**RE: Drainage Certification for Oakland Court Subdivision (C20-D35) Dated
January 7, 2003**

RE: Drainage Report for Oakland Court Subdivision (C20-D35) Dated April 23, 2002

OAKLAND COURT SUBDIVISION LOTS 1 THRU 6

RE: Engineer's Drainage Re-Certification – 8838 Oakland Court, NE (Lot 6, Oakland Court Subdivision.)
Hydrology File: C20/D35

EXHIBIT "A"

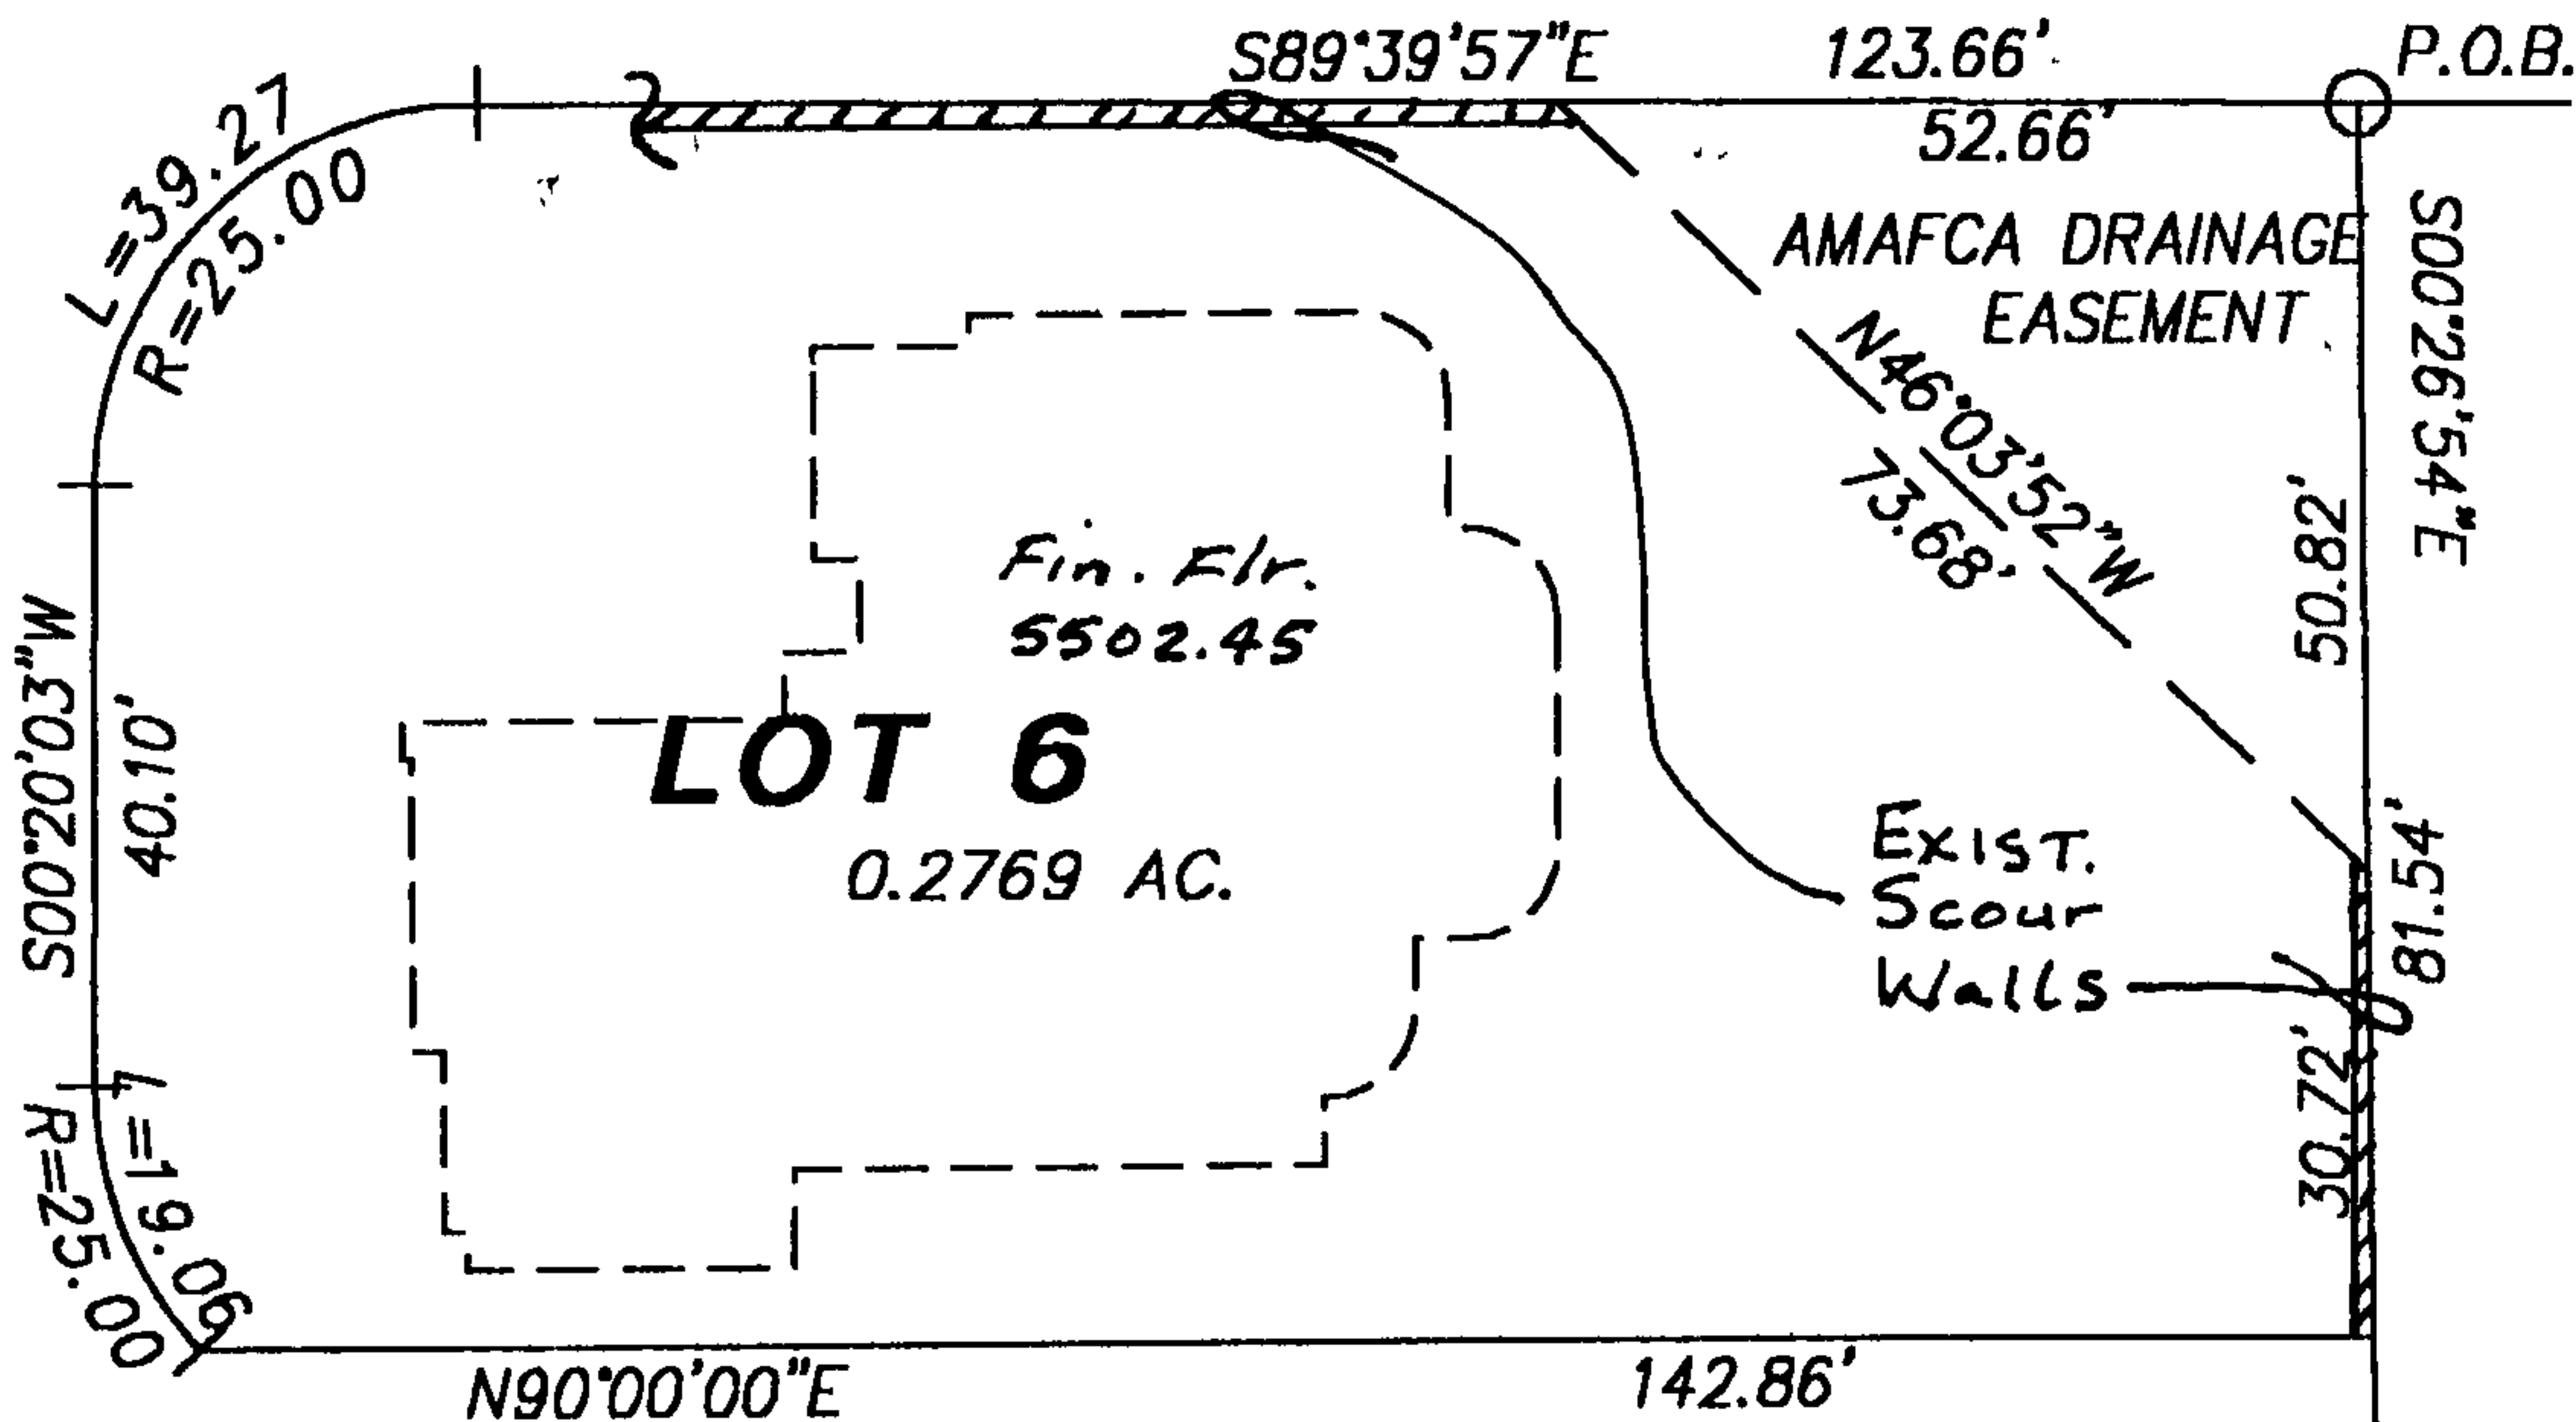
The triangle piece in the floodplain at 8838 Oakland Court needs to be dedicated to AMAFCA as an easement. I have attached a private Facility Drainage Covenant document that needs to be filled out and submitted to the City for the cutoff walls. Originally we had the house behind the wall. Now because the house is next to the floodplain you need to resubmit the scour calculations for review. Please show the velocity and Froude Number next to the house versus using the average numbers. The house is next to the floodplain and it may need extra scour protection. Please submit a new drainage plan to show how you are going to stay out of the floodplain and include the structural drawings for the foundation and the walls. Could you please check the location of the existing wall next to the floodplain to see if it is in the location that is shown on the existing drainage plan.

The following responds to your letter of February 12, 2003. Please find the drainage easement based on an improvement survey by Phil Turner, P.S. performed in May 2003 with the scour walls delineated, and as-constructed to this date. The field inspection was performed by my office this past week, and the easement has been filed with the County Clerks Office by Martin Eckert, Real Estate Officer, at AMAFCA.

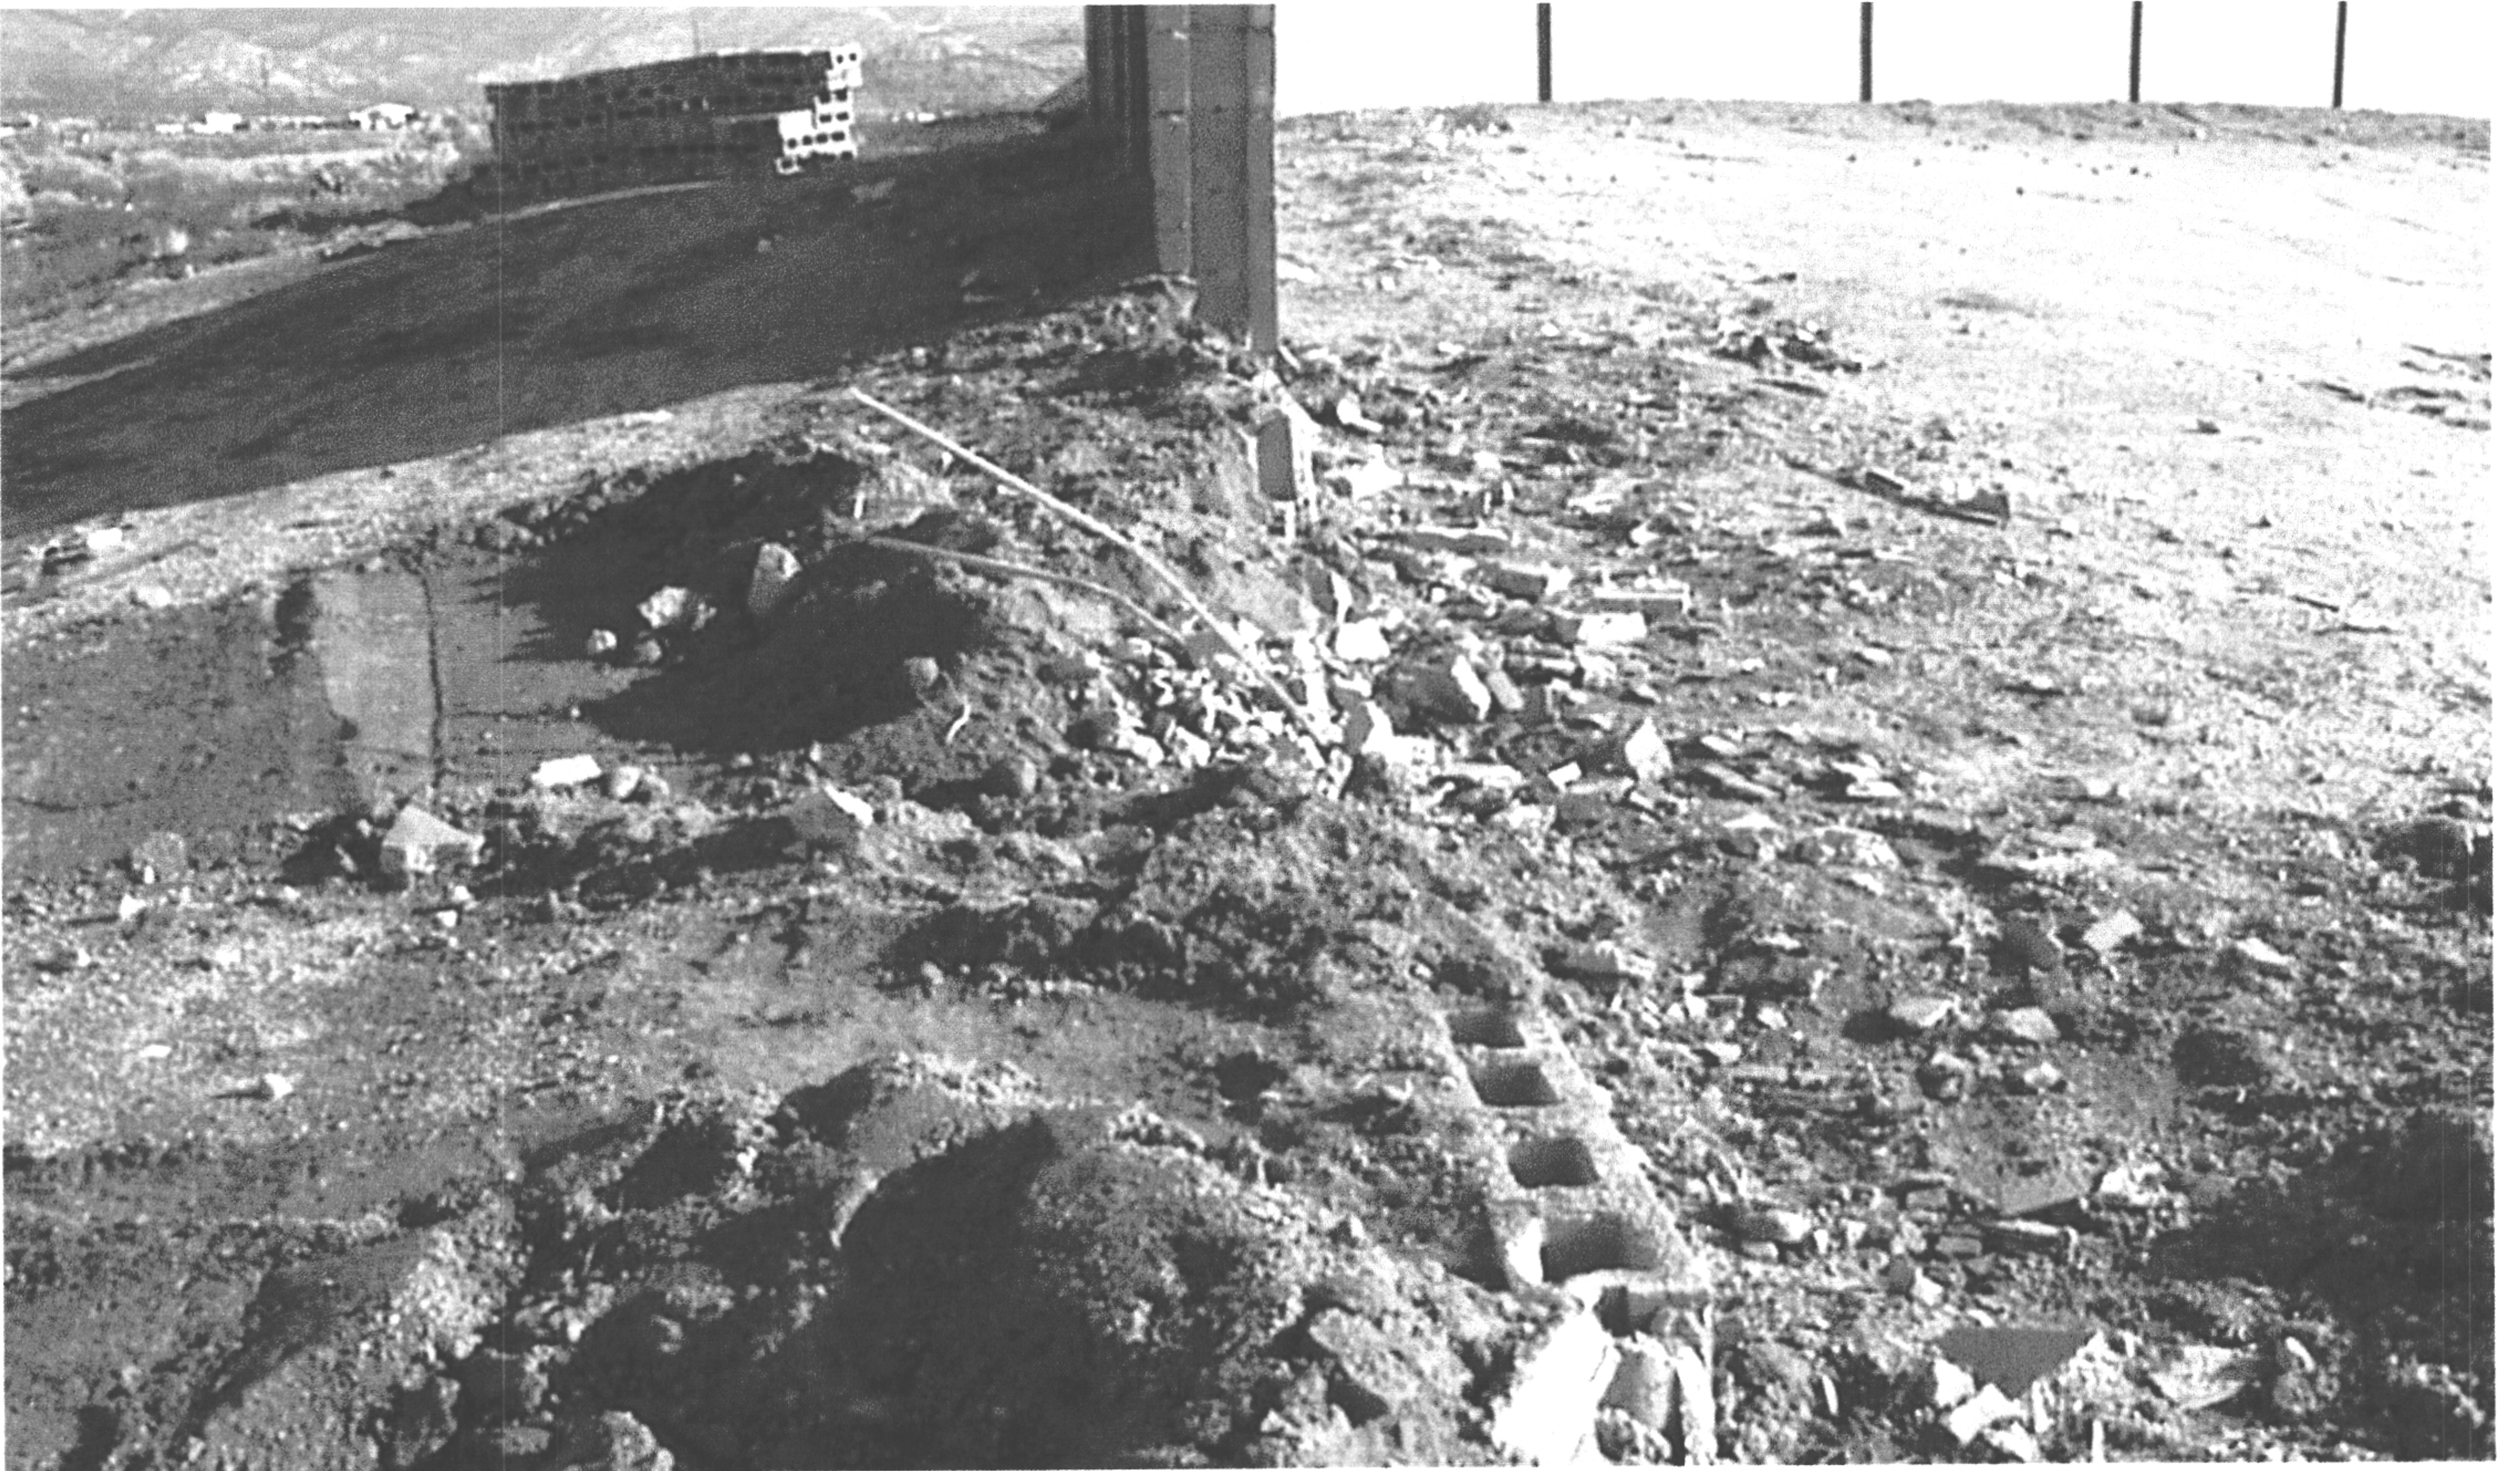
Lot 6 again,looking southeast. This wall was supposed to extend down for erosion protection (how far down is a real question), which means it should have been designed as a retaining wall. It doesn't look like a retaining wall in this photo.

Lot 6 looking northwest. Notice construction extending beyond floodwall, geeting close to apparent arroyo flowpath. ?Is this per approved plan? ?Per properly approved plan?
